**Assessment of Seven (7) Protected-Size Trees
at and adjacent to
15897 Camino Del Cerro
Los Gatos, California**

Prepared for:
Ryan Safty, Associate Planner
Town of Los Gatos Community Development Department
110 E. Main Street
Los Gatos, CA 95030

Report by CTA
7/20/2020

The CTA marked up the applicant's sheet C-2 grading and drainage plan.

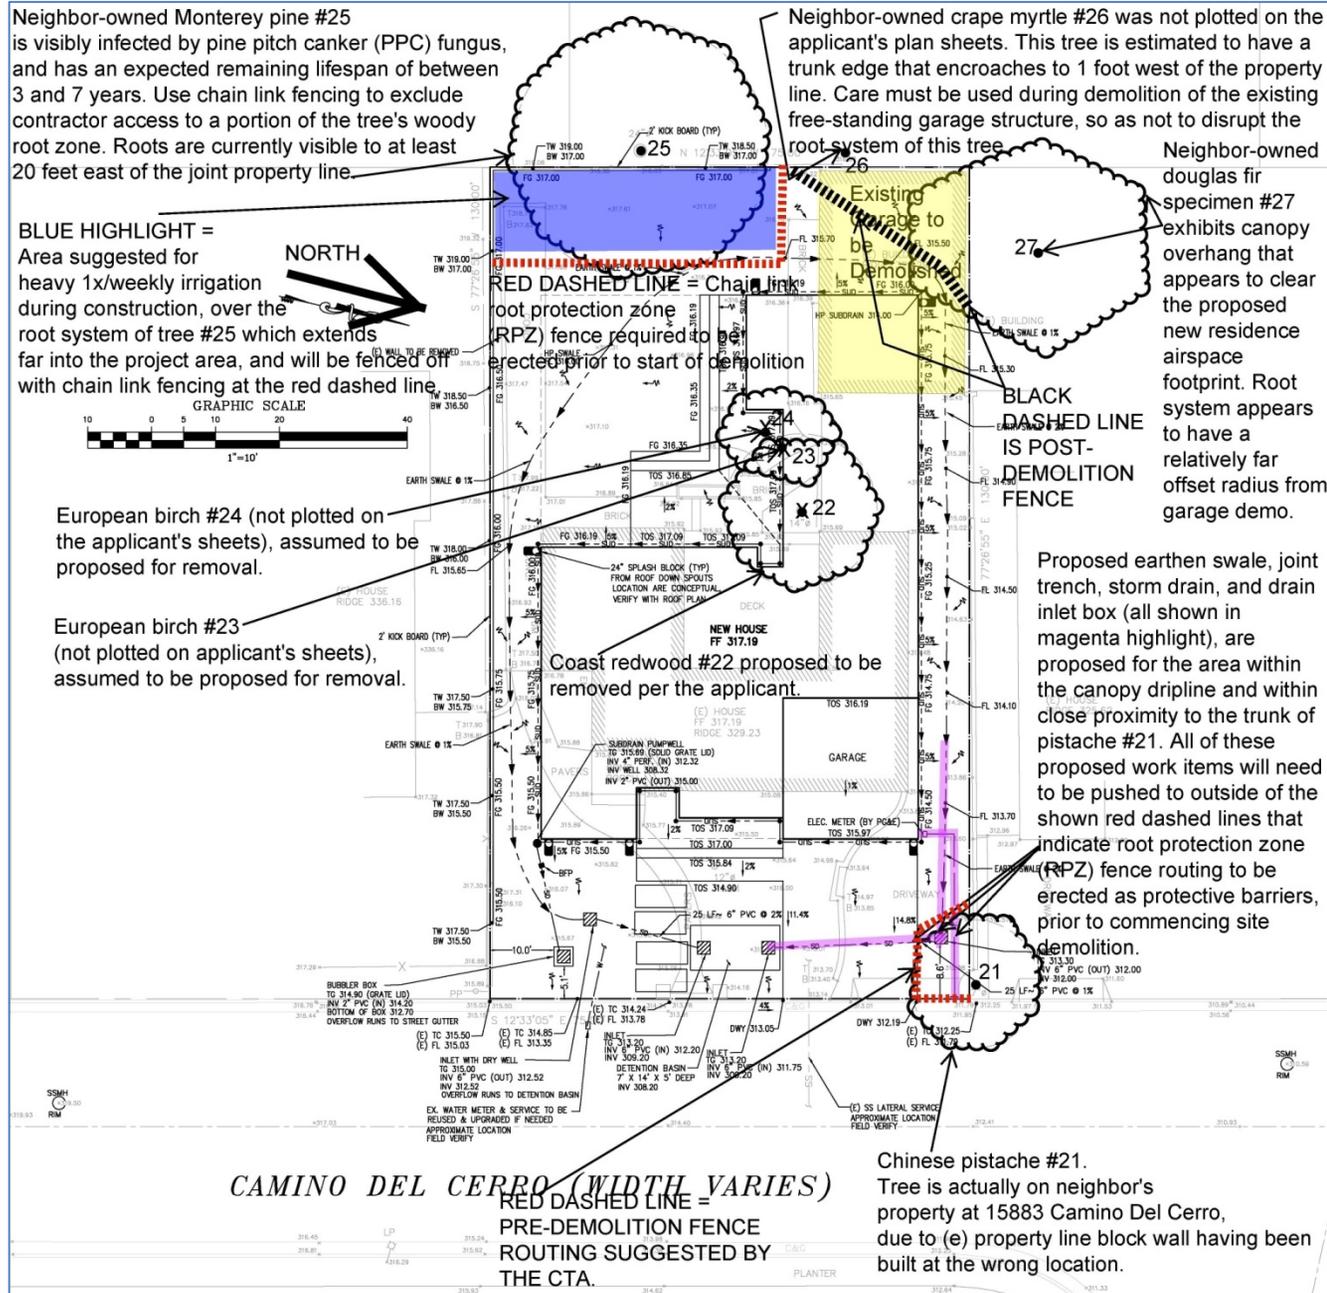
Set up chain link fencing per the red dashed line routes shown on the CTA's tree map markup at the end of this report, around trees #21 and #25.

The area to be fenced off for tree #25 root zone protection will measure approximately 50 feet north-south by 15 feet east-west, effectively encompassing the entire southwest corner of the project area, per the CTA's tree protection map.

Immediately (same day as demolition of garage is complete), erect chain link root protection zone fence along the route shown on the CTA's tree protection map at the end of this report, to protect the above-ground canopy of neighbor tree #27.

2e. STORM DRAIN (SD) PIPES AND BOXES: The applicant shall push the proposed graded swale, proposed storm drain inlet box, proposed storm drain pipe trench, and the proposed joint trench, all to at least 12 feet from trunk edge of tree #21, so that RPZ fencing can be erected at 10 feet offset radius from the trunk of this tree and maintained at that distance throughout the entire construction project.

See the CTA's red-dashed lines indicating chain link fence routing, on the attached tree map markup (TREES #21 and #25).

Post-demolition fence addition: Add fencing per the black-dashed line on the CTA's tree map markup (TREES #26 and #27).
